**UNITED STATES
NUCLEAR REGULATORY COMMISSION**
WASHINGTON, D.C. 20555-0001

**SUBJECT: HOPE CREEK GENERATING STATION – STAFF ASSESSMENT OF
RESPONSE TO 10 CFR 50.54(f) INFORMATION REQUEST – FLOOD-
CAUSING MECHANISM REEVALUATION (CAC NO. MF3789)**

STAFF ASSESSMENT BY THE OFFICE OF NUCLEAR REACTOR REGULATION
RELATED TO FLOODING HAZARD REEVALUATION REPORT
NEAR-TERM TASK FORCE RECOMMENDATION 2.1
HOPE CREEK GENERATING STATION
DOCKET NO 50-354

Figure 3.2-3. Precipitation Hyetograph Used in the Local Intense Precipitation Analysis (FHRR Figure 2.1-2 (PSEG, 2014a))

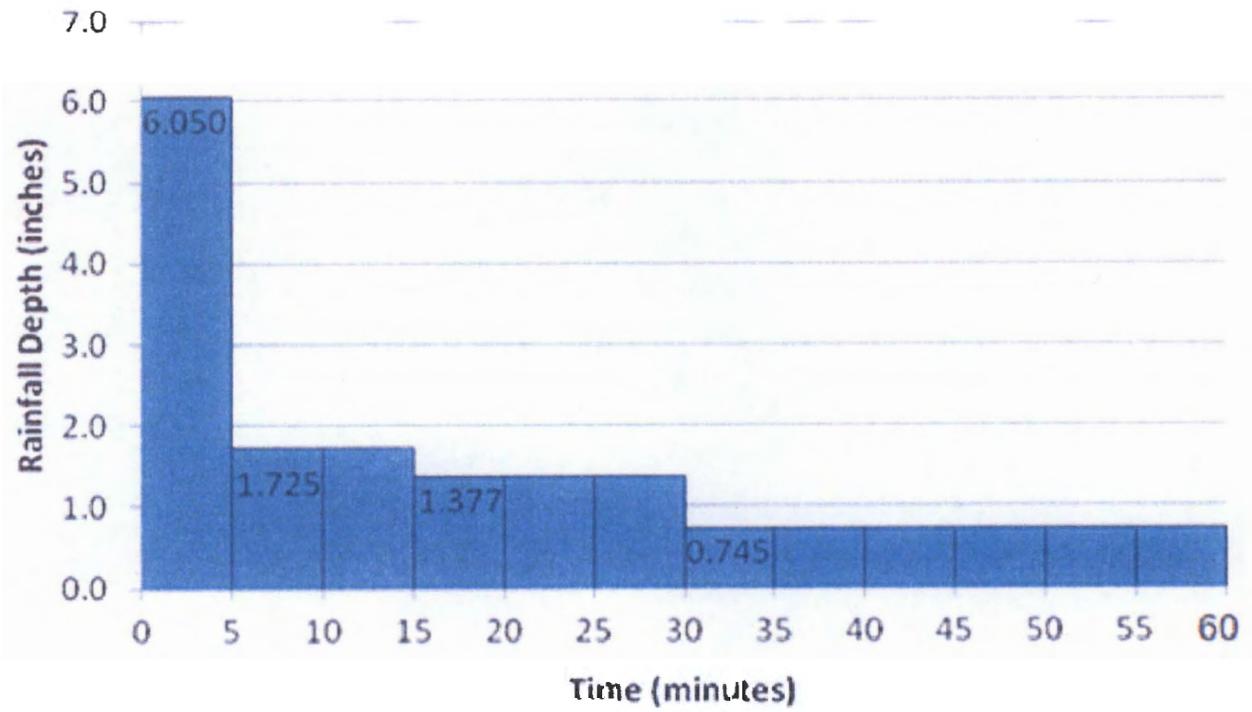
The licensee stated that the PMP precipitation hyetograph, shown in Figure 3.2-3 was developed using the methodology described in NUREG/CR-7046 (NRC 2011e). The licensee used 5-min increments to construct the hyetograph, with the most intense precipitation flux applied during the initial 5-min increment with the precipitation rate decreasing during successive time increments (PSEG, 2014a). The NRC staff verified that the licensee followed the example described in Appendix B of NUREG/CR-7046.
